SC3 SOLDIER CREEK COAL CO.

Re: Incidental Boundary Change

SOLDIER CANYON MINE

10 Acre Incidental Boundary Change

SCALE: 1" = 500'	TITLE: FIGURE 1 - 10 ACRE INCIDENTAL BOUNDARY CHANGE	DRAWING NO.
DRAWN BY DGS / DATE 5/15/89	CHECKED / DATE / APPROVED / DATE

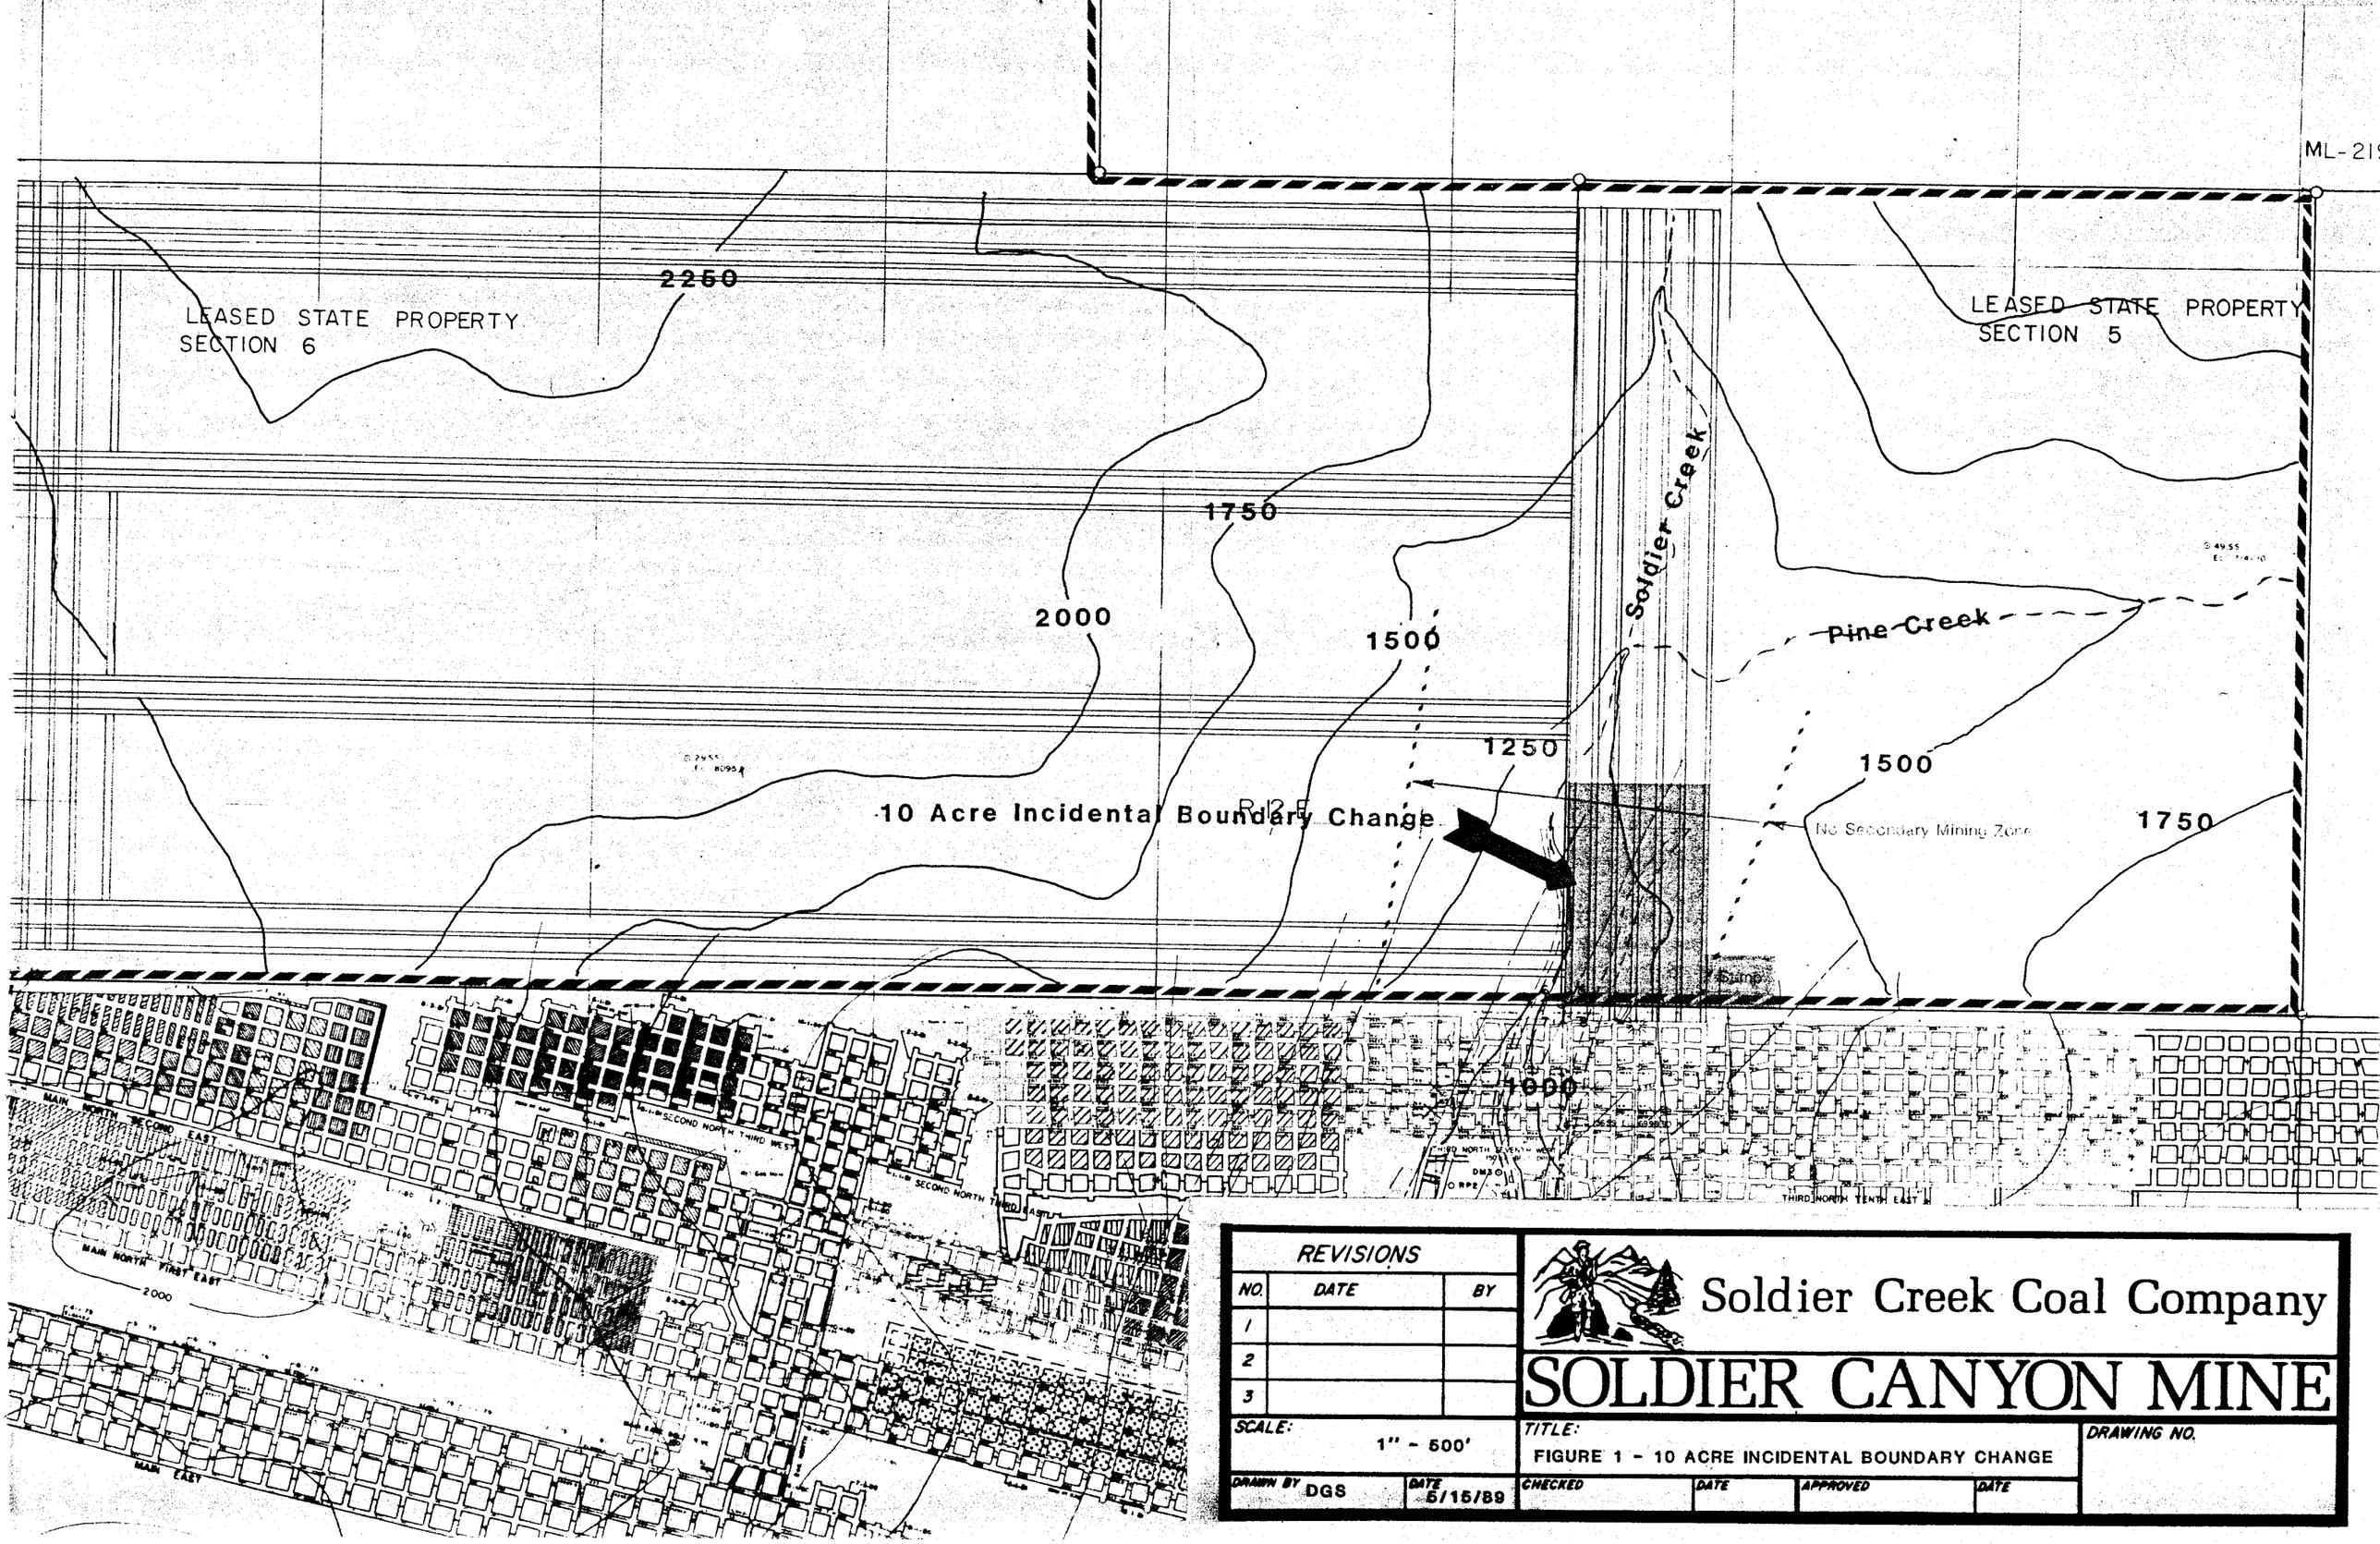
The proposed 10 acre IBC is shown on Figure 1. Please note that the IBC has been modified slightly from the April 14 submittal. This modification was necessary to allow for the development of a mine water sump.

SCALE: NONE	TITLE: Figure 2 - Zone of No Secondary Mining	DRAWING NO.
DRAWN BY DGS / DATE 5/15/89	CHECKED / DATE / APPROVED / DATE

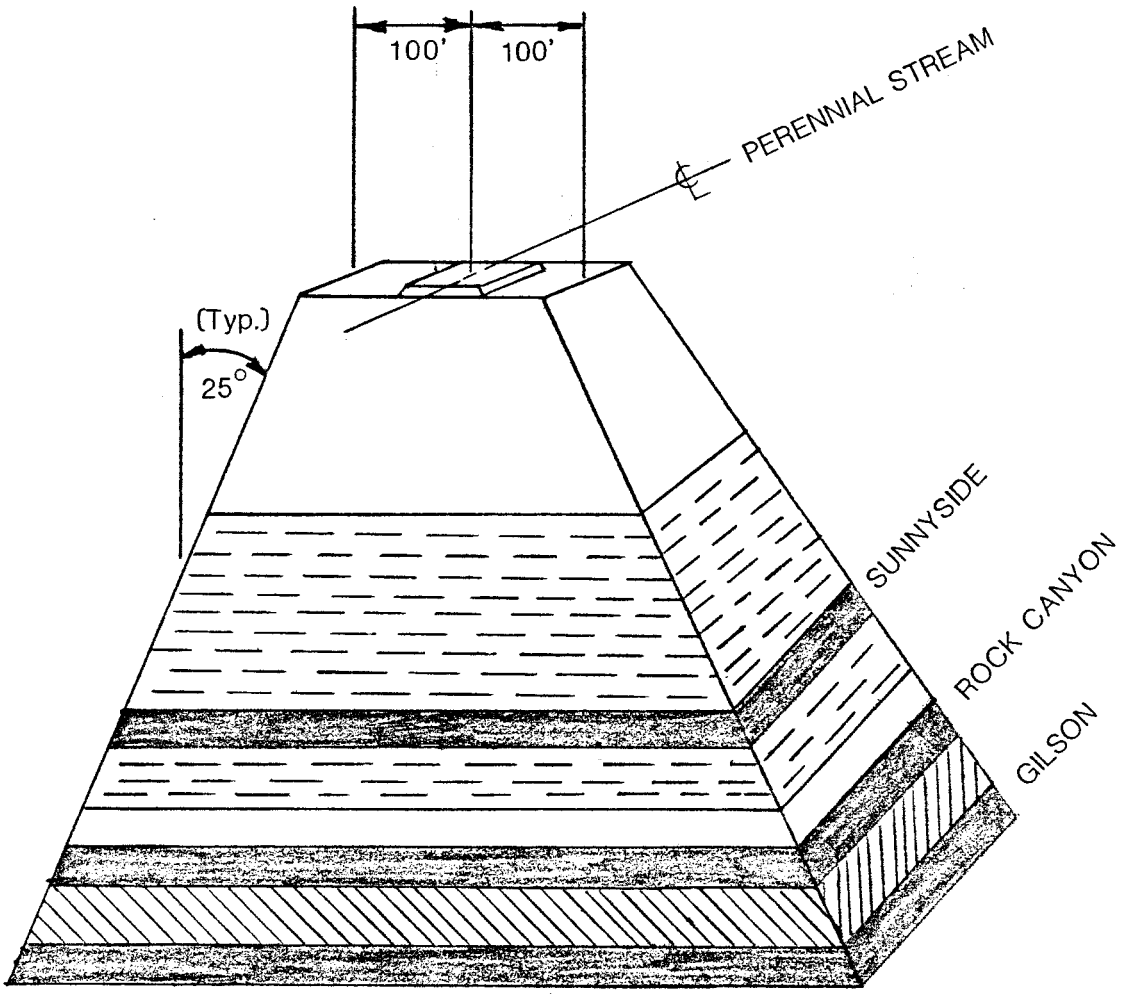
On April 14, 1989, Soldier Creek Coal Company (SCCC) submitted a request for a 10 acre Incidental Boundary Change (IBC). Following the Division's preliminary review of this submittal, concerns were raised over the proposed mining plans located beneath Soldier Creek, a perennial stream.

SCCC believes that pillars of sufficient size, left in place, shall provide adequate protection to eliminate any adverse effects to Soldier Creek. Therefore, pillar design calculations, as well as a profile of the no secondary mining zone (Figure 2) have been enclosed for your review. Also, SCCC shall commit to a minimum pillar size of 60 ft. x 60 ft. with mining operations confined to the Rock Canyon Seam only.
